COMMENTS AND RESPONSES | VOLUME 1: CHAPTERS 1-5

California Pacific Medical Center (CPMC) Long Range Development Plan

PLANNING DEPARTMENT CASE NO. 2005.0555E

To: Members of the Planning Commission and Interested Parties
From: Bill Wycko, Environmental Review Officer
Re: **Attached Comments and Responses on Draft Environmental Impact Report
Case No. 2005.0555E: California Pacific Medical Center (CPMC) Long Range
Development Plan**

Figure 2-18 (Revised)

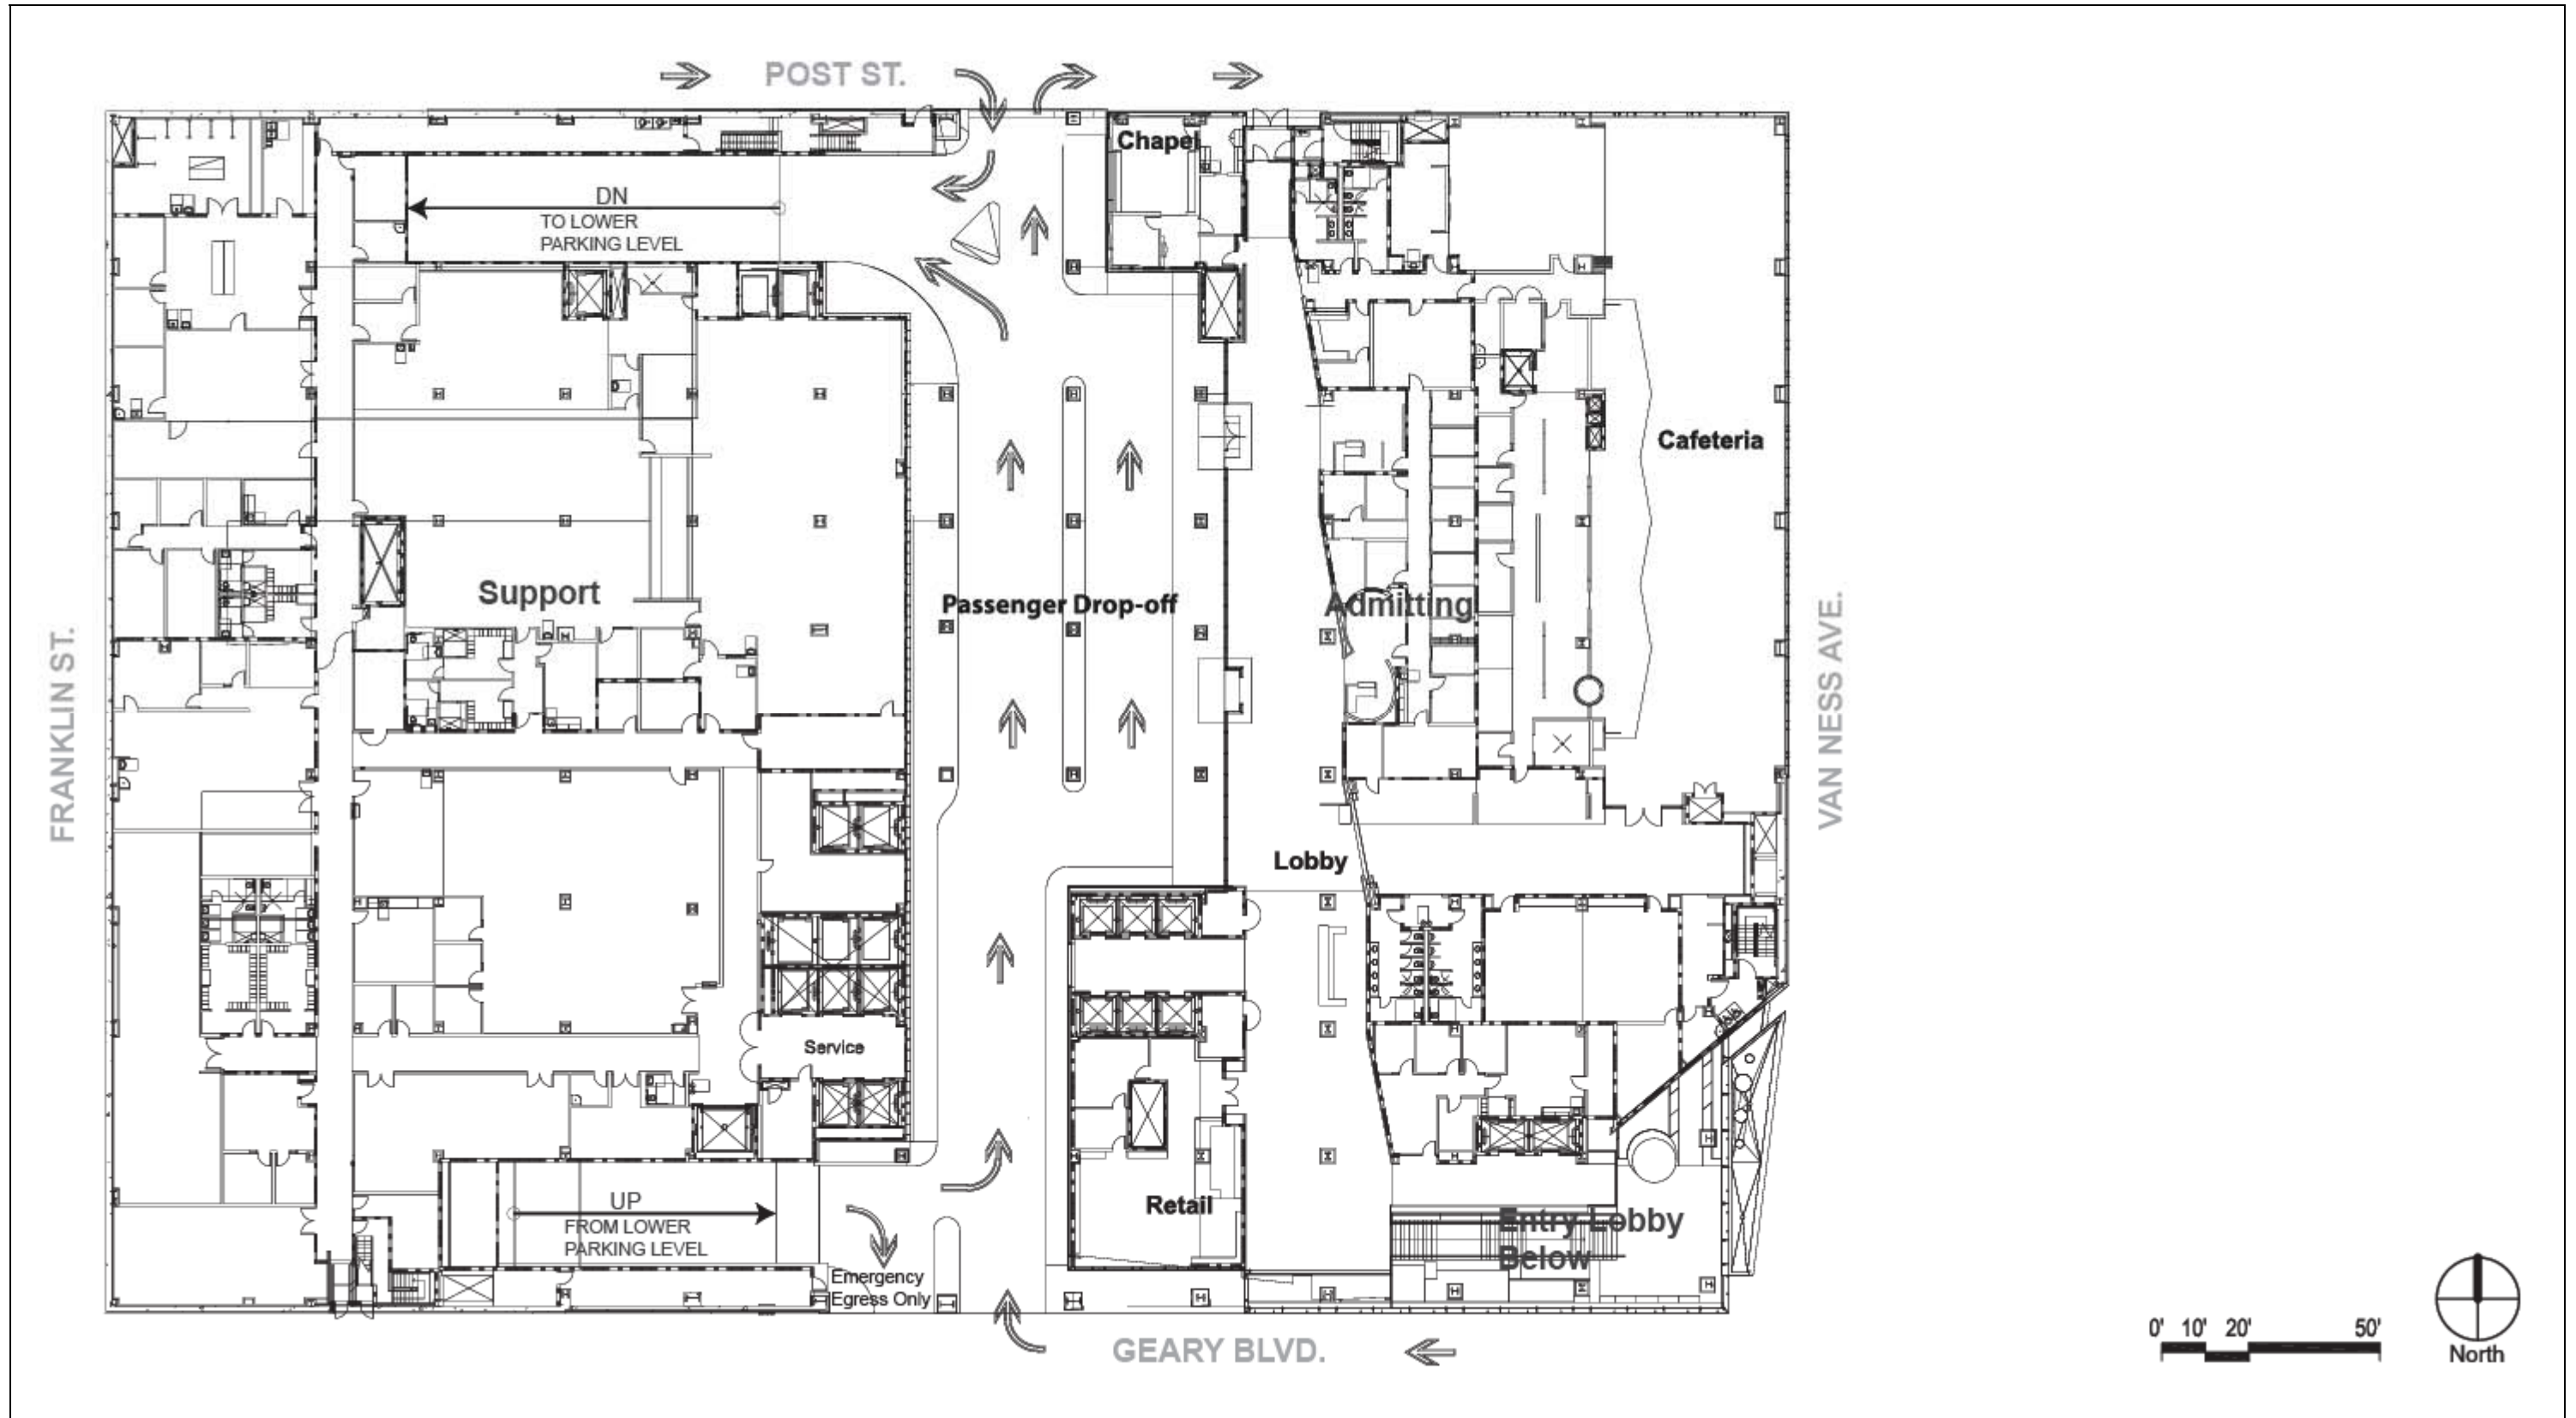
Figure 2-18, “Cathedral Hill Hospital-Level 2” in the Draft EIR, page 2-75, has been revised to correct an error regarding garage egress as follows:

Figure 4.5-26 in the Draft EIR, page 4.5-207 “St. Luke’s Campus – Proposed Passenger Zones” has been revised for clarification to show the correct passenger zones at the St. Luke’s Campus under the proposed CPMC LRDP. The revised figure is presented below:

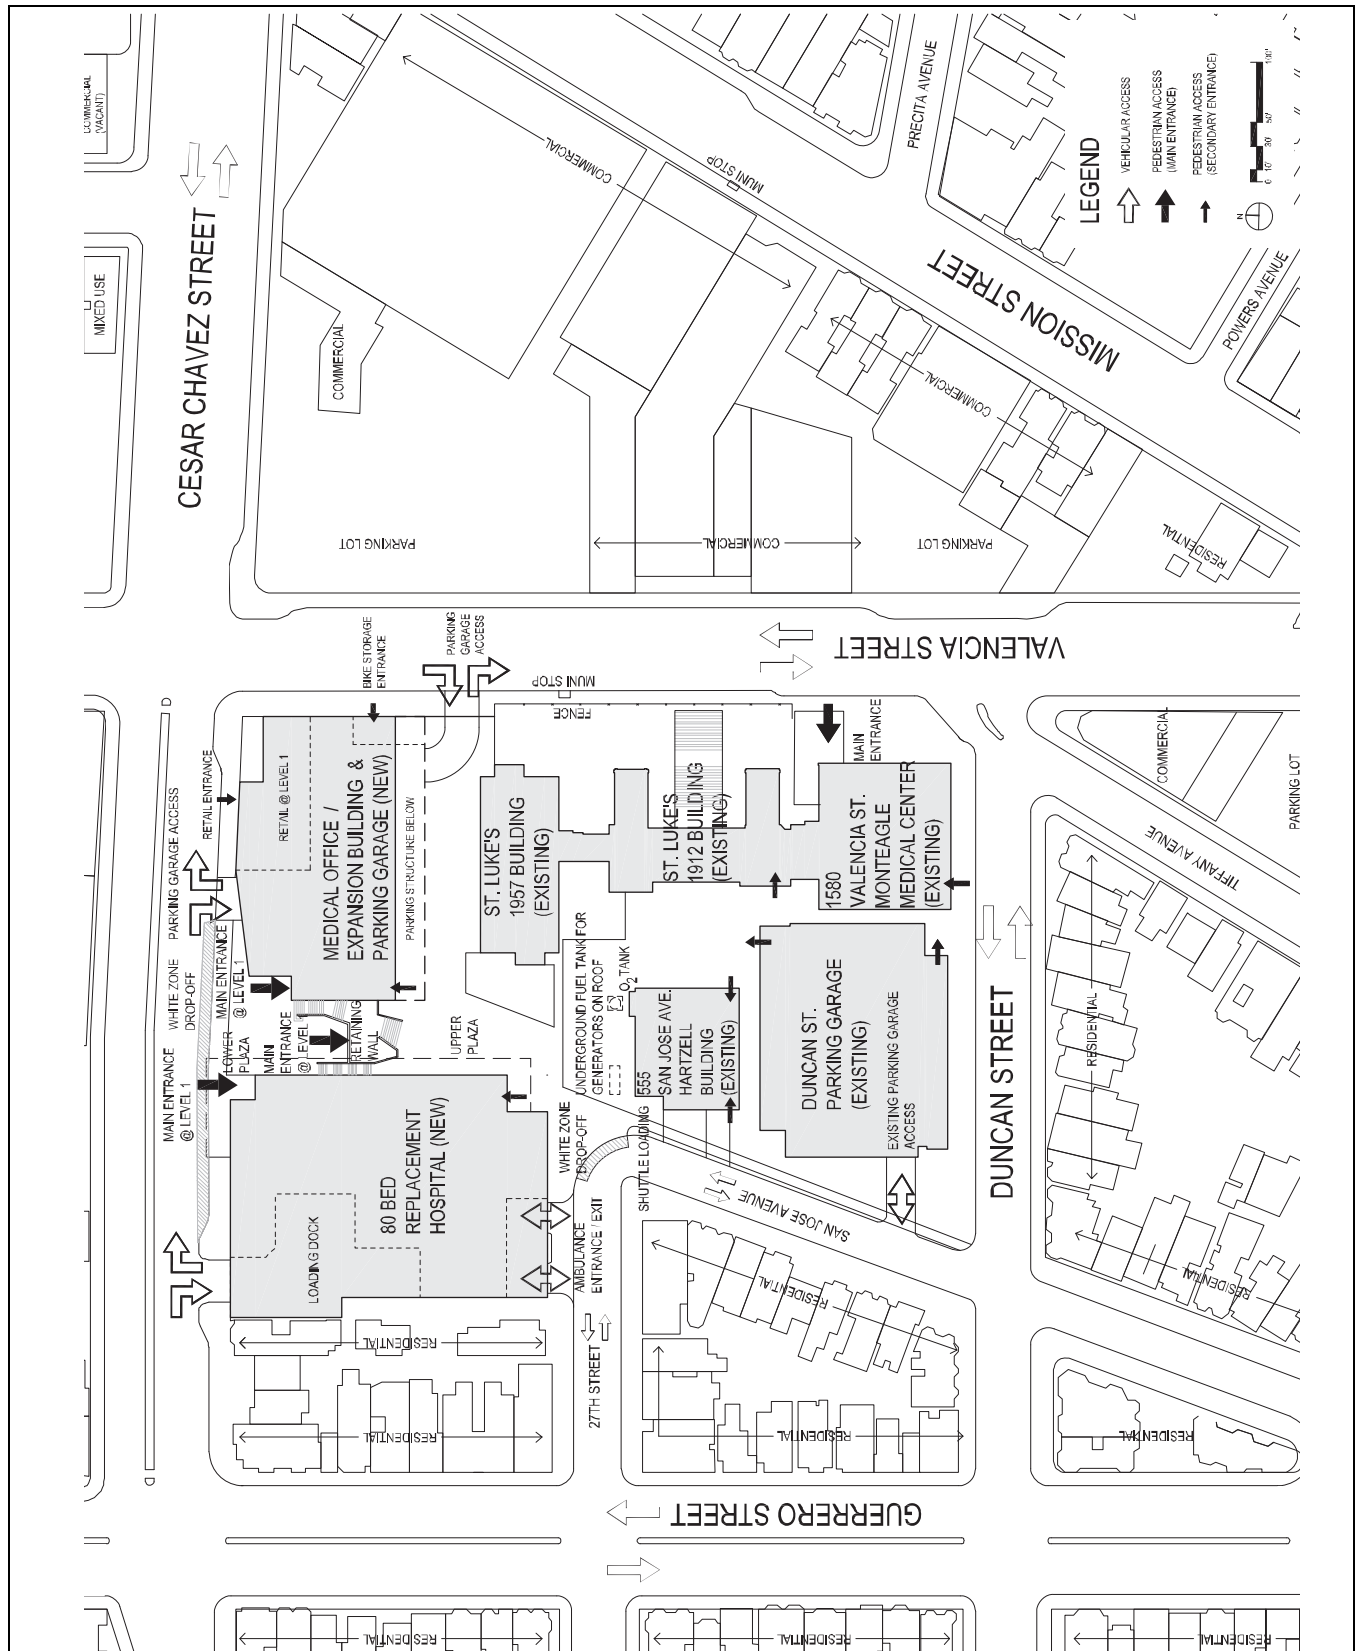
“Page 4.5-207: The location of the emergency department and associated ambulance bay, and the three loading docks, trash and medical waste receptacles shown in Figure 4.5-26 differs from the location shown in Figure 2-59, St. Luke's Campus Variant 1-Alternate Emergency Department Location, as well as Figures 2-63 and 2-64 (elevations), 2-68 and 2-69 (sections), and 2-71 and 2-72 (floor plans), and 2-77 (landscape plan), in Chapter 2, Project Description. Therefore, the analysis of traffic and noise impacts and the conclusion of less-than-significant impacts are based on incorrect plans. The analysis is therefore fundamentally flawed and must be revised and the DEIR must be recirculated for meaningful public disclosure and comment.”

The comments are correct in noting that Figure 4.5-26 was a different site plan than shown in the above-stated project description figures. The incorrect Figure 4.5-26 was mistakenly inserted into the Draft EIR

Figure 4.5-26 in the Draft EIR, page 4.5-207, has been revised for clarification to show the correct locations of the proposed passenger zones at the St. Luke’s Campus under the LRDP. Refer to Chapter 4 of this C&R, page C&R 4-79, for revised Figure 4.5-26.
